**PERFORMANCE AUDIT ON THE CONSTRUCTION OF DAR ES SALAAM  
BUS RAPID TRANSIT (BRT) INFRASTRUCTURE- PHASE 2**

**A REPORT OF THE CONTROLLER AND AUDITOR GENERAL OF THE UNITED  
REPUBLIC OF TANZANIA**

March, 2021

**Photo 4.1:** Frame type B constructed at Kariakoo Terminal sheds taken on 20<sup>th</sup> October, 2020.

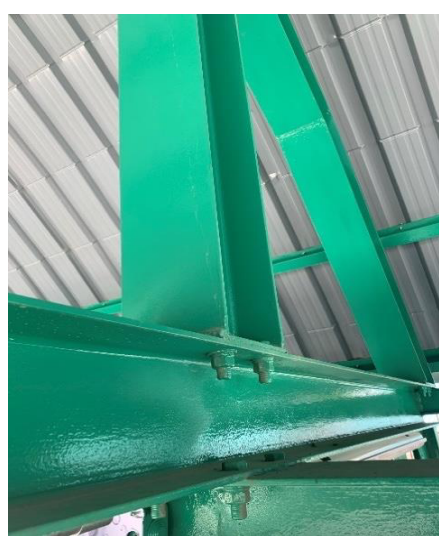
According to IPC No. 8 which was issued on 22<sup>nd</sup> December, 2020 part of the overpayment on Frame Type A was deducted from this IPC, hence the remaining overpayment for frame Type A is **TZS 103,477,920**.

Kariakoo Terminal Shed Frame Type B

Column Break and Change in Cross-section

According to drawing No. T497-BRT2L2-KRK-TSA-ST-06 of terminal Shed for Frame Type A details, the columns were supposed to bear a cross section dimension of (200x200x52) mm with the height of 5,305 mm long. However, the result of the joint measurement showed that the height of the columns is 3,700 mm which implies a difference of 1,605 mm.
